802.3da Mixing Segment Specifications

July 2024

- **Comments D1.3**
- **168.8.2 Mixing Segment return loss Equation (168–4) is TBD**

168.8.2 Return loss

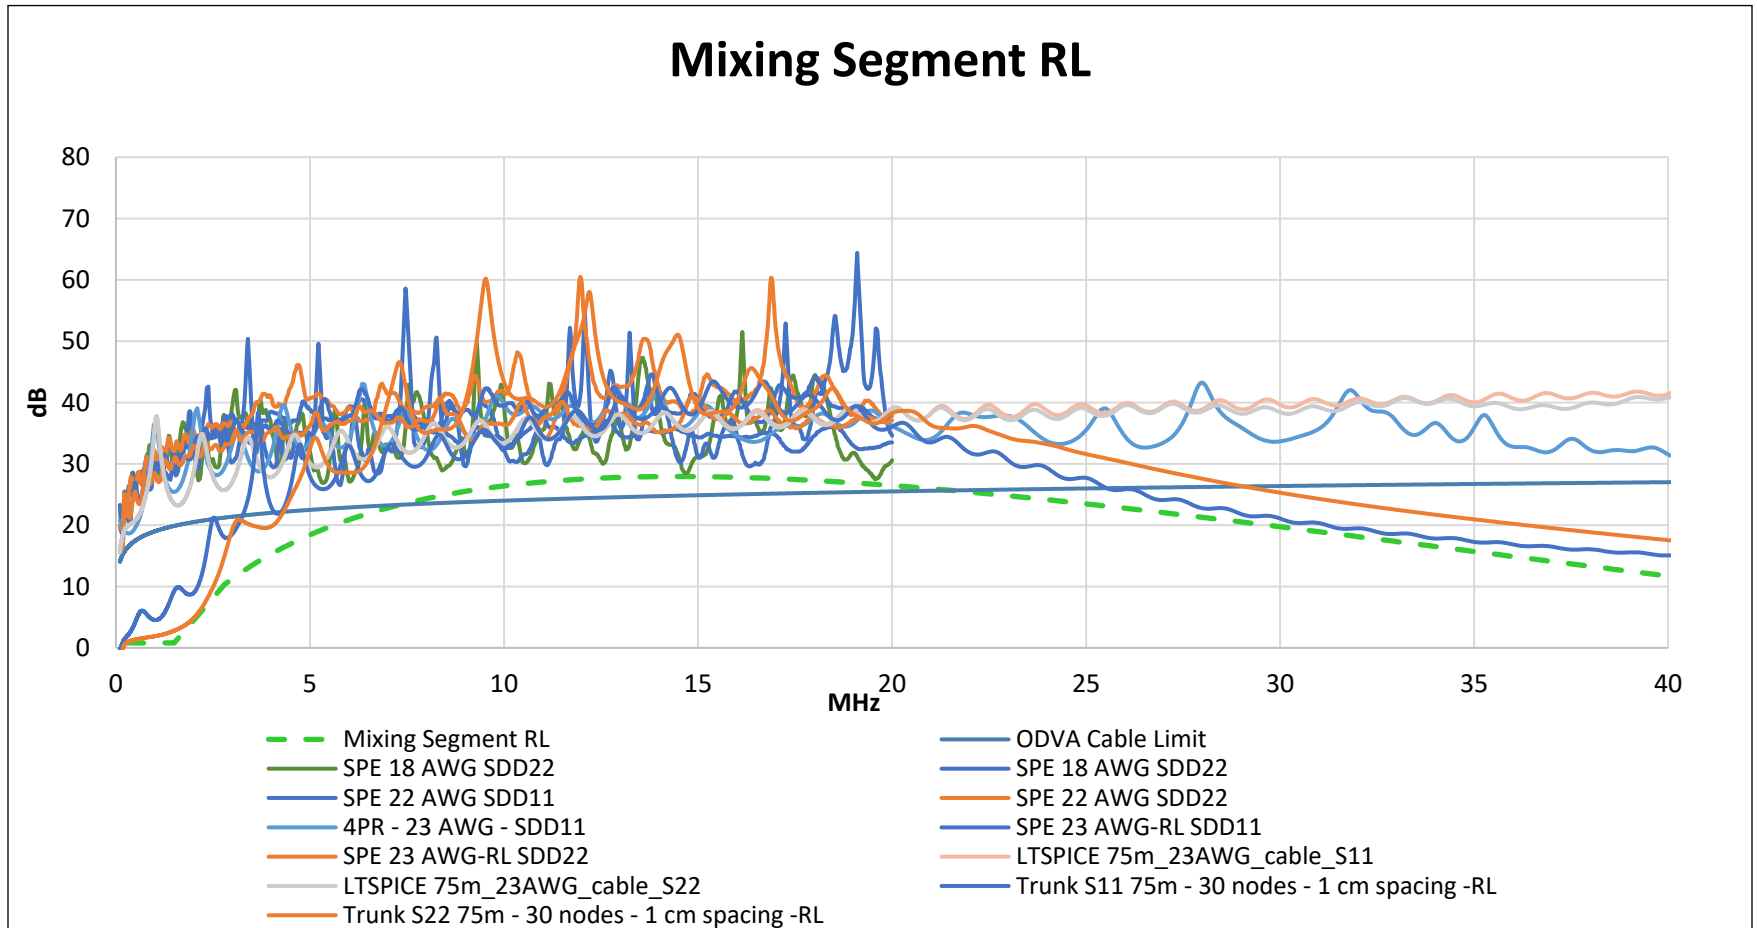
- **Comments D1.3**
- **168.8.2 Mixing Segment return loss Equation (168–4) is TBD**
- **Use RL equation below (from slide 10)**

The mixing segment return loss, with PMA or PMA loads present at the TCI connections. with DTEs attached shall meet the values determined using Equation (168–4) at the edge terminations. The reference impedance is 100 Ω.

$$RL \geq 0.8$$

$$(7.34 * f(\text{MHz})) - 10.21$$

$$-42.5 + ((-20 * \text{LOG}(f(\text{MHz}))) - (0.024 * 1/f(\text{MHz}))) + (47.5 * \text{SQRT}(f(\text{MHz}))) - (6.39 * f(\text{MHz})) + (0.0259 * f(\text{MHz})^2)$$

$$0.3 \leq f(\text{MHz}) < 1.6$$

$$1.6 \leq f(\text{MHz}) < 2.8$$

$$2.8 \leq f(\text{MHz}) \leq 40$$
